Monticello Nuclear Generating Plant
2807 W County Road 75
Monticello, MN 55362

L-MT-12-002
10 CFR 50.90

License Amendment Request: Revise and Relocate Pressure Temperature Curves to a
Pressure Temperature Limits Report

**REVISE THE TECHNICAL SPECIFICATIONS TO INCLUDE A
PRESSURE TEMPERATURE LIMITS REPORT**

Figure 3.4.9-1
Core Beltline Operating Limits Curve Adjustment Versus Fluence

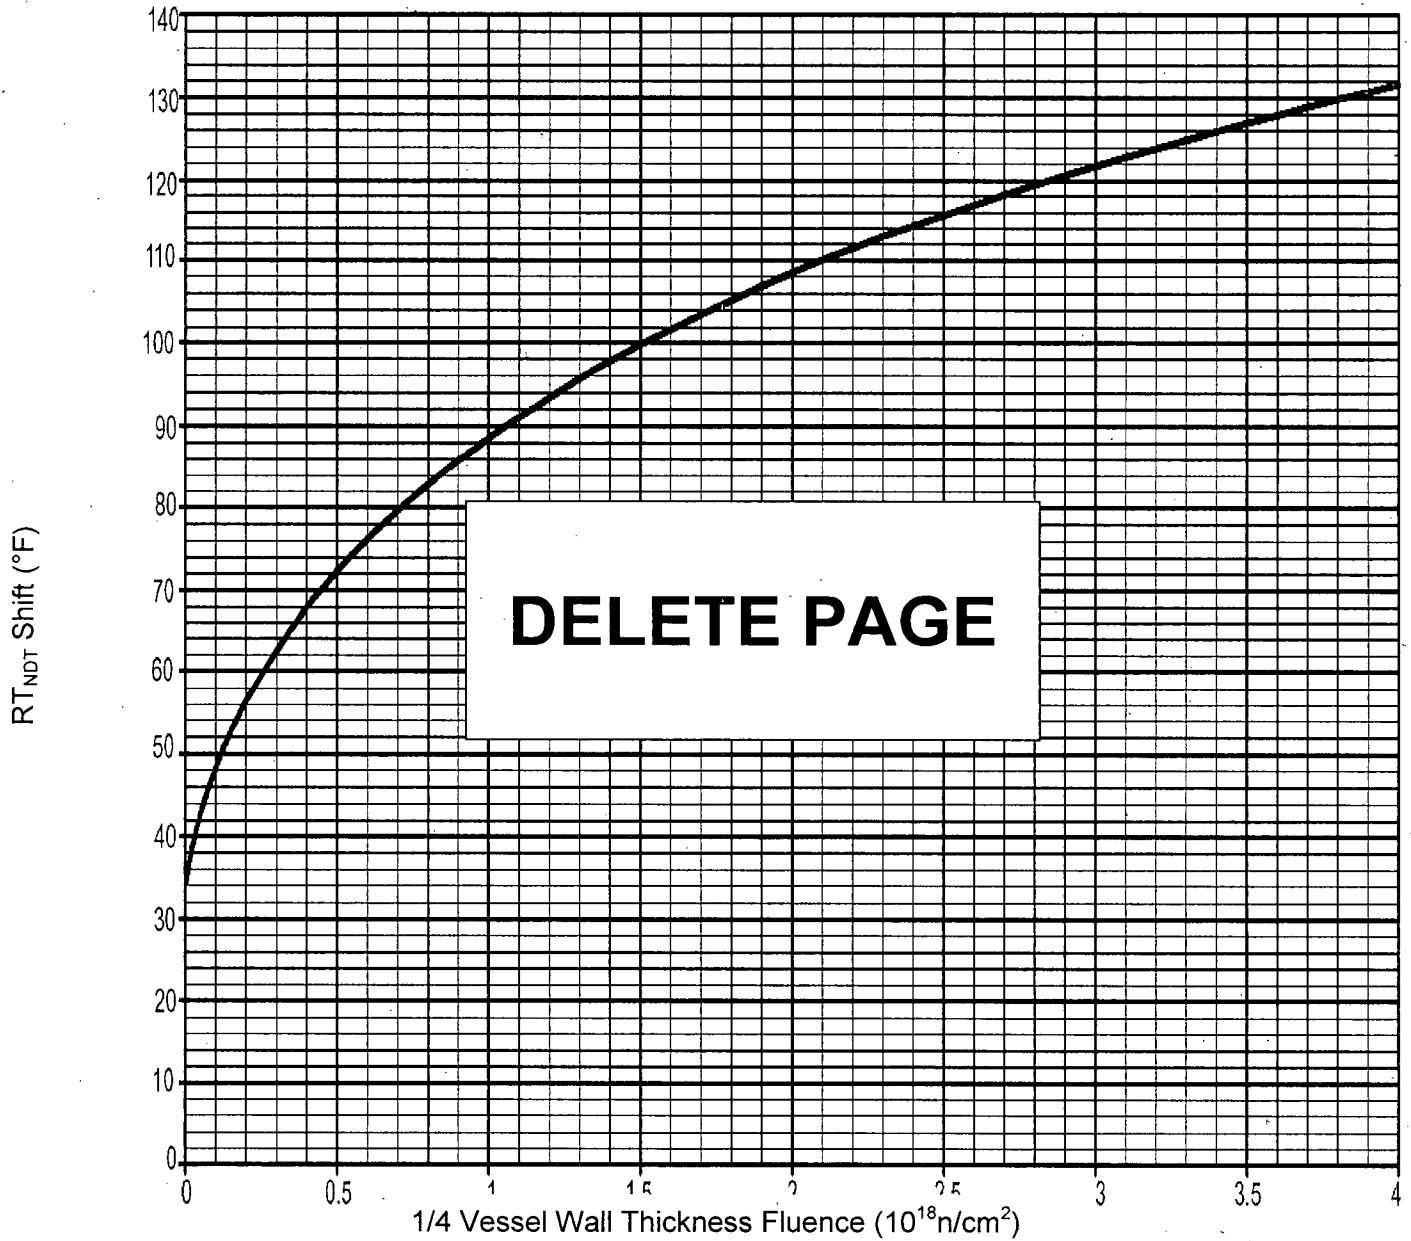
- The first non-conservative TS condition discovered is that with incorporation of recent surveillance specimen capsule results TS Figure 3.4.9-1, "Core Beltline Operating Limits Versus Fluence," becomes non-conservative in approximately 2026. This figure is part of the current MNGP specific methodology (not part of the SIA methodology) and will be removed with approval of this amendment, eliminating this condition.
- The second non-conservative TS condition is that sufficient fluence had accumulated for the recirculation inlet nozzles to enter the beltline region. These nozzles are now a limiting component under low temperature / low pressure conditions. Procedural controls have been put in place to prevent entry into this region during hydrostatic testing.

1. Incorporation of recent surveillance specimen results have resulted in current TS Figure 3.4.9-1, "Core Beltline Operating Limits Versus Fluence," curve becoming non-conservative in approximately 2026. (This curve is part of the current MNGP P-T methodology and will be eliminated with adoption of the SIA methodology via this amendment.)
2. Determination that the recirculation inlet (N2) nozzles are in the beltline region⁽⁴⁾ of the vessel and are a limiting component for low temperature / low pressure conditions.

Calculational results incorporating these changes indicate that current TS Figure 3.4.9-1, "Core Beltline Operating Limits Curve Adjustment Versus Fluence," will become non-conservative in approximately 2025 at the current rate of fluence accumulation. This condition is being treated as a non-conservative TS in accordance with NRC Administrative Letter 98-10.

Figure 3.4.9-1 is part of the current MNGP specific P-T methodology. This figure allows the core beltline operating limits to be adjusted for fluence under the current MNGP methodology. This adjustment capability is NOT part of the BWROG SIA methodology. Figure 3.4.9-1 will be eliminated following adoption by the MNGP of the BWROG SIA methodology with the approval of this amendment – precluding this condition in the future.

- 6) Remove the present P-T curves, i.e., Figure 3.4.9-1 through Figure 3.4.9-4.
 - 7) Add a new Specification 5.6.5, "Reactor Coolant System (RCS) Pressure and Temperature Limits Report (PTLR)," to Subsection 5.6, "Reporting Requirements," in Section 5.0, "Administrative Controls." The format and content is according to TSTF-419-A. This new specification:

Figure 3.4.9-4
RCS Pressure Versus Temperature Limits
Critical Operation

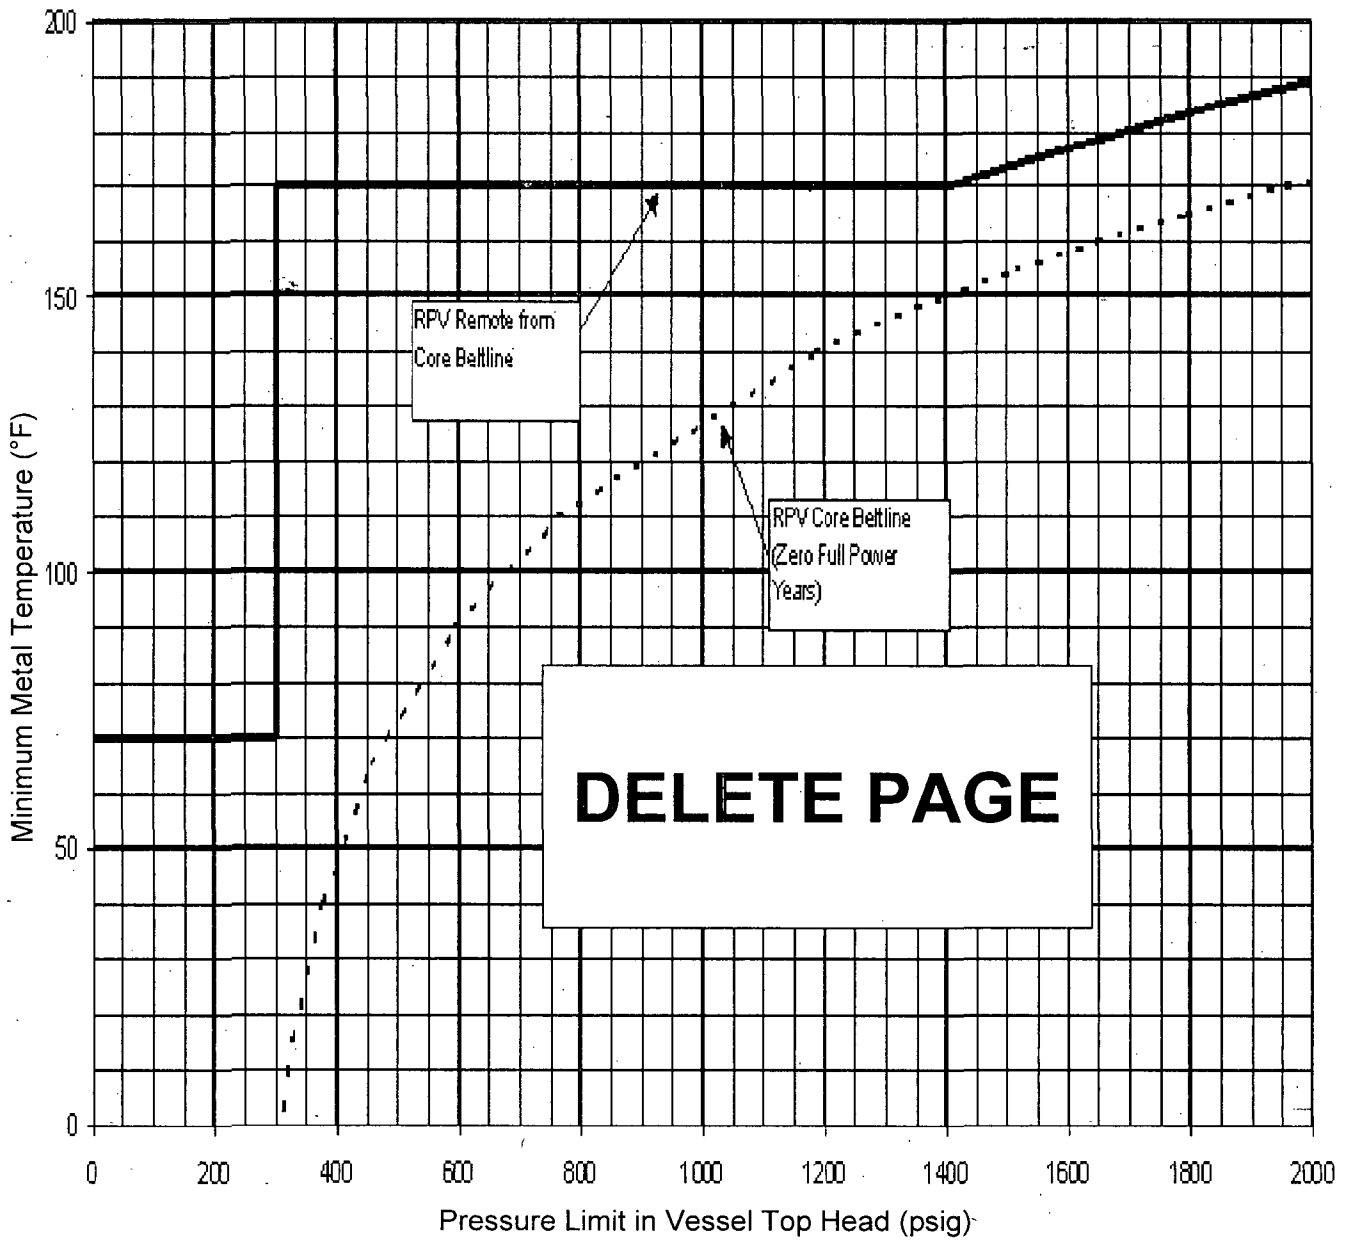
~~This SR has been modified by a Note that requires Figure 3.4.9-4 to be adjusted as required by Figure 3.4.9-1 (core beltline temperature adjustment) for the reactor vessel shell and fluid temperatures. This ensures the proper RCS pressure and temperature limits are met based on reactor fluence.~~
